[DRAFT] MEMORANDUM

TO: Plan Commission
Village of Twin Lakes

FROM: GRAEF
Larry Witzling, Senior Planner & Urban Designer
Dominic Marlow, Planner & Urban Designer

SUBJECT: Conceptual Review for the proposed Sunset East Subdivision at 2301 E Lake Shore Drive

Figure 2: GRAEF Recommended Future Connection to Matthew Avenue (Source: Applicant – “Concept Plan”)

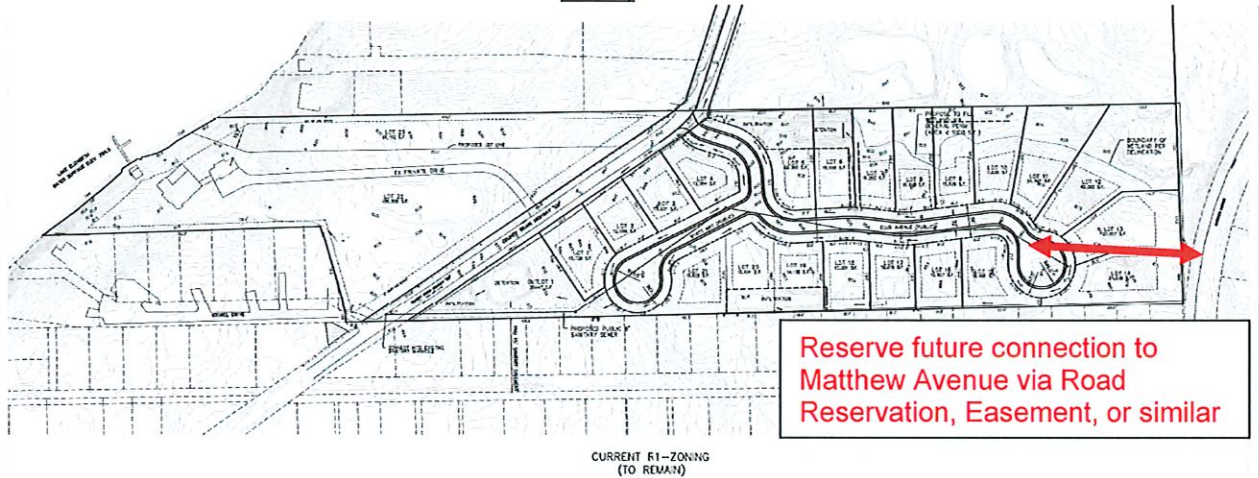
The proposed street named Ellis Avenue on the Draft Preliminary Plat terminates approximately ~200 feet away from Matthew Avenue. The Applicant does not own the land which would allow for a connection to Matthew Avenue. Construction of a street in anticipation of connection to Matthew Avenue should be discussed given the following considerations:

- Section 16.24.030 of the subdivision code states that the width of blocks shall be sufficient to allow two (2) tiers of lots of appropriate depth.
 - ***GRAEF recommends to the Plan Commission the consideration of a future public street constructed in anticipation of future connection to Matthew Ave which would create a new block of approximately ~1,000 feet in length and with sufficient width to allow for two tiers of lots of appropriate depth. This would need to be discussed with the larger residential area.***

- ***In lieu of such a public street connection, GRAEF recommends to the Plan Commission the consideration of pedestrian and bicycle paths constructed with or without future connection to Matthew Avenue.***

- ***GRAEF recommends to the Plan Commission the requirement of a temporary cul-de-sac or T-type turnaround determined by the Village Department of Public Works for the construction of a new residential street in anticipation of future connection with Matthew Avenue to the east.***

- Upon revision of the site plan based on the Plan Commission’s recommendation, a reserved future connection to Matthew Avenue should be included specifying the method of reservation. If a revised site plan significantly reduces the need for a street connection to Matthew Avenue based on the criteria outlined in this Section F of this memorandum, then such a reservation may not be appropriate.
- Without a connection to Matthew Avenue, Schoors Lane will likely be utilized for most local traffic access into the subdivision from certain directions.

Figure 4: Post-Cleared Woodlands (May 2021) Google Earth

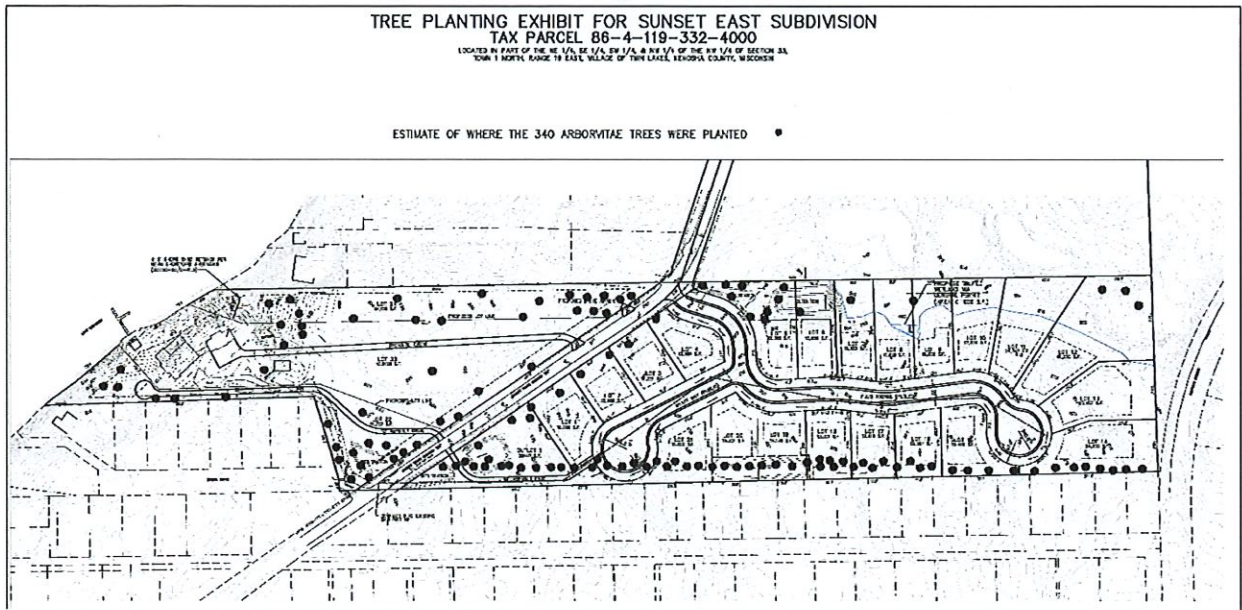
*Note: Photo taken as of May 2021. Current status of woodlands clearance should be provided by the applicant including number, species, and locations of trees replanted.

CONCEPT PLAN FOR SUNSET EAST SUBDIVISION

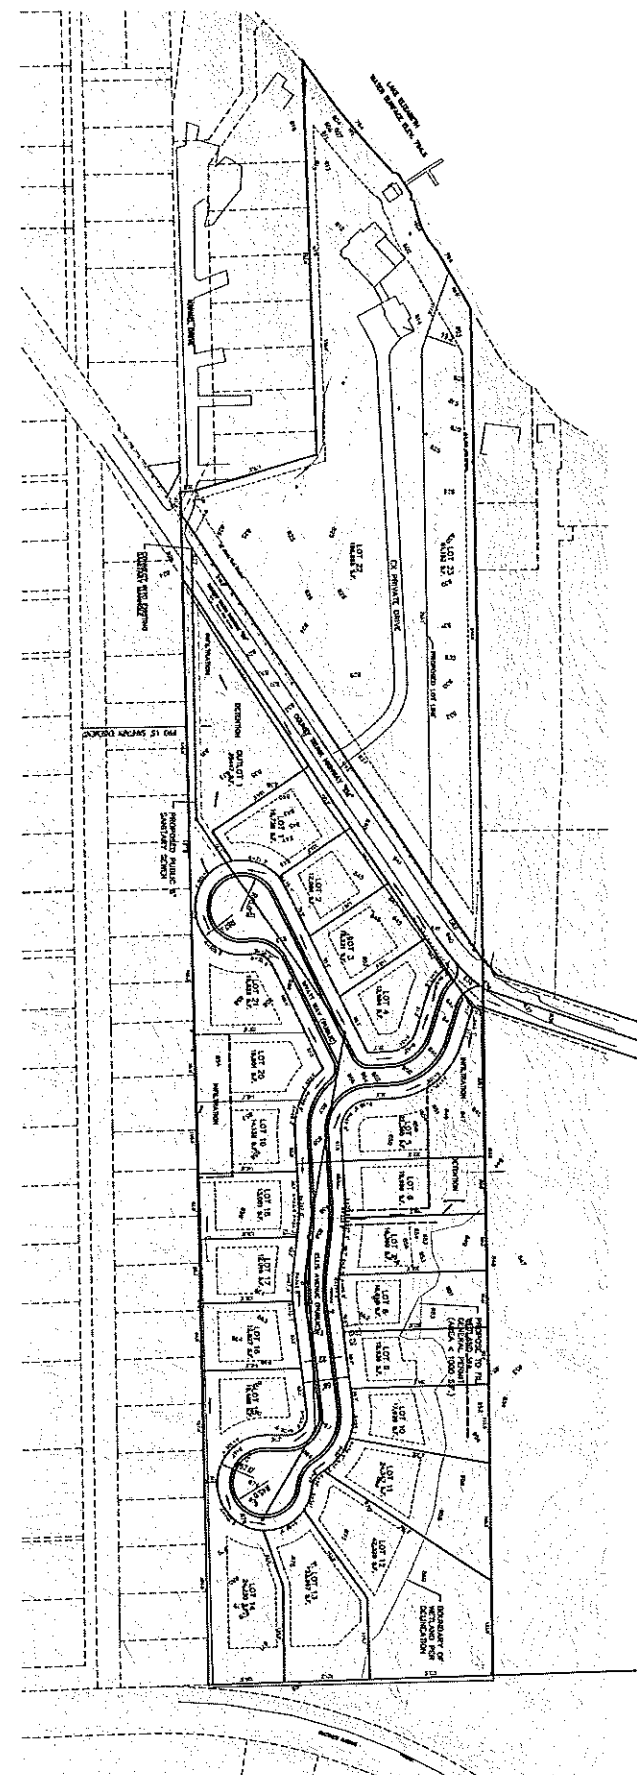
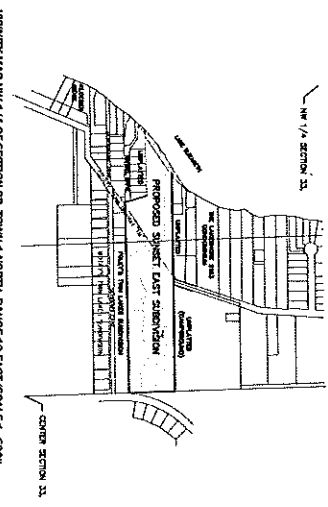
REVIEW STANDARD	COMMENTS
16.16.060 Accessways and Private Entrances.	<i>Accessways and private entrances on major streets shall be kept at a minimum. Lake Shore Drive is a County Trunk Highway. The proposed plan includes one private drive, one asphalt drive, and one drive apron on the west of Lake Shore Drive. The Village Engineer and Chairman of the Street Committee should determine the appropriate vehicular access onto a curved section of Lake Shore Drive for recommendation to the Plan Commission. Applicant should specify the types of vehicles intended for the 10 foot asphalt drive to the south in Lot 22.</i>

16.16.080 Street Widths.	<i>Minor residential streets should have a minimum right-of-way of sixty-six (66) feet. Right-of-way for streets does not appear to be indicated on submittals. Cul-de-sac length appears to exceed maximum length of four hundred (400) feet allowed but dimensions do not appear to be indicated on submittals. Will require approval as an exemption. Cul-de-sac width and radius appear to be less than minimum sixty-six (66) feet in width and seventy-five (75) feet radius. Will require approval as an exemption.</i>

16.15.090 Road Systems.	<i>Plan Commission and/or Village Board may wish to require the extension of the proposed ELLIS AVENUE to the next available intersecting street, Matthew Ave. A walking path connection to Matthew Ave. may be an appropriate alternative to prevent too many intersections with the traffic way.</i>
Chapter 16.24 Subdivisions: Blocks and Lots

16.24.090 Depth of Residential Lots.	<i>Lots must be one hundred (100) feet deep. The final design for lots 5, 6, 19, 20, and any substantially changed lots should be reviewed for compliance upon review of the Preliminary Plat. Lot depth dimensions do not appear on all lots.</i>

16.28.030 Storm Water Drainage.	<i>Ditch and pond formation goes along the two adjacent property lines. The easements for storm water drainage appear to be marked with dark dashed lines but not indicated as easements on the submittals.</i>
Chapter 16.33 Subdivisions: Open Space and Public Use Areas

16.33.020 Reservation of Potential Sites.	<i>Lake access is proposed in Lot 22 via ten (10) foot asphalt drive. Plan Commission may determine that a portion of the plat is required for public site or open spaces through purchase of the portion within five (5) years.</i>

- *Applicant should redesign cul-de-sacs to appropriate standards where feasible, rather than seek exemption.*
 - *Applicant should state in which cases they wish to seek exemption from residential street design standards and why those standards cannot be met technically, such as cul-de-sac radius and cul-de-sac length.*

- *Applicant should clearly indicate and label easements for storm water drainage on subsequent submissions.*
- The subdivision codes states that the Plan Commission may determine that a portion of the plat be required for public access to the lake, reserved for purchase for not longer than five (5) years.
